CITY OF ALLENTOWN

R63 – 2024

Certificate of Appropriateness for work in the Historic Districts:

**Historical Architectural Review Board
FINAL Review Sheet**

Front Deck (Applicant)

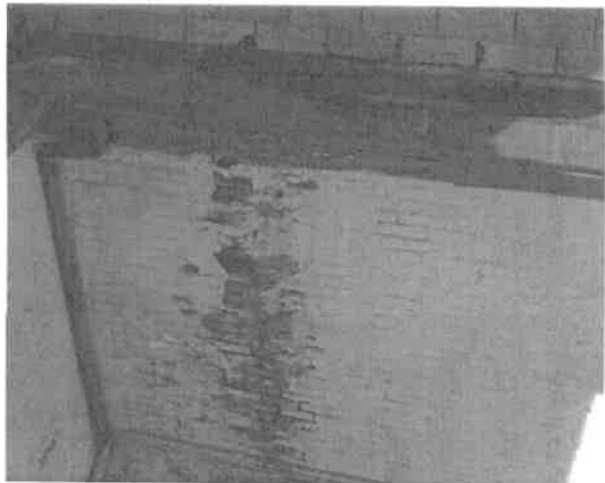
The proposed work at the front porch and railings is also consistent with the design guidelines.

Front of House (Applicant)

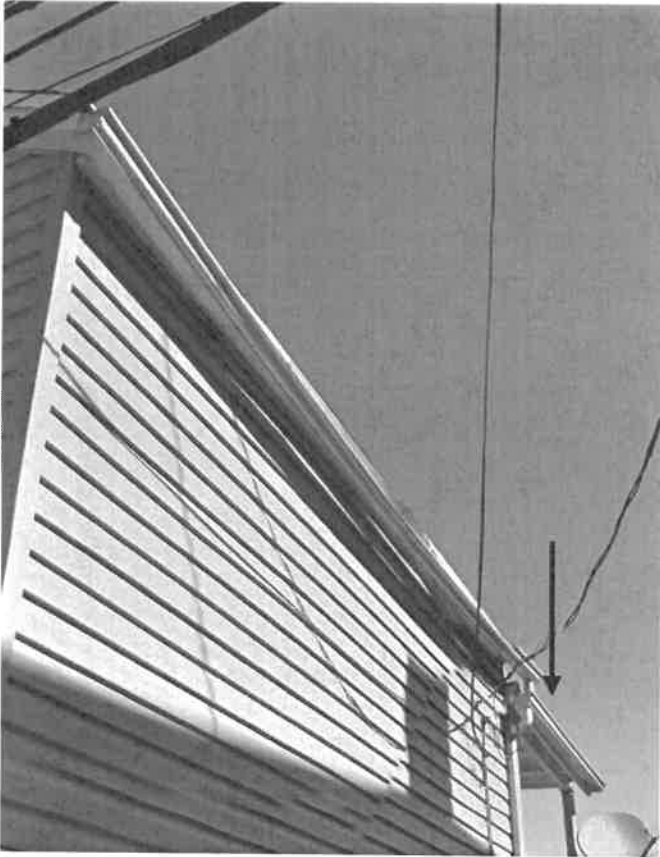
Observations & Comments: The current 3-tab asphalt shingles on the main gable roof are not historic and the proposed replacement material (GAF Timberline HDZ Shingles) are architectural shingles that have an exaggerated taper and overlap; it would be historically appropriate to either replace with 3-tab shingles to match the existing in style or color, or to replace with GAF slateline shingles, which would be more historically appropriate. The flat slope roof is not visible and therefore, the replacement with the SBS roofing is acceptable. The description did not include any work done to the gutters, but if any work is done, it is recommended to use half rounds, as opposed to the k-style that are currently installed.

Discussion: The applicant noted that there are no plans to replace the gutters. The applicant agreed to use a GAF Slateline or similar 3-Tab shingle to match the existing style and color of the current roofing instead of the architectural shingle proposed. No concerns were noted for the flat roofs, as the proposed replacement material was appropriate.

Window Condition (Applicant)

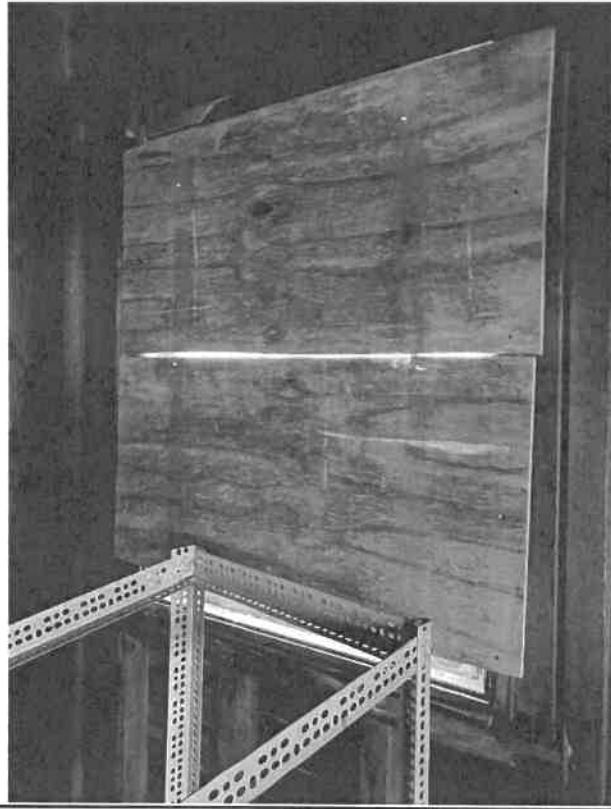
View: West side of the building in alley, first floor; window is damaged, doesn't work.

View: West side of building in alley, first floor; window doesn't work, gaps at the bottom, broken pulls.

Discussion: Generally, it was discussed that the applicant did not meet the burden of proof to show that the windows needed to be replaced. It was noted that based on the provided photographs, the windows looked as if they only needed routine maintenance and did not require full replacement. The applicant indicated that the photographs may not accurately document the conditions of the window, but the replacement is to protect the building from vandalism and prevent further deterioration. Given that the proposed replacement is historically appropriate and the concern for vandalism, most agreed that the proposed replacement was appropriate.

Action: Mr. Jordan made a motion to amend the previously approved application from March 4, 2024 with restated conditions as of April 1, 2024 to replace the windows at 1515-1559 Linden Street with the following conditions agreed to by the applicant following sections of the Guidelines for Historic Districts: Chapter 3, Section 3.5 Windows and find that there are not circumstances unique to the property:
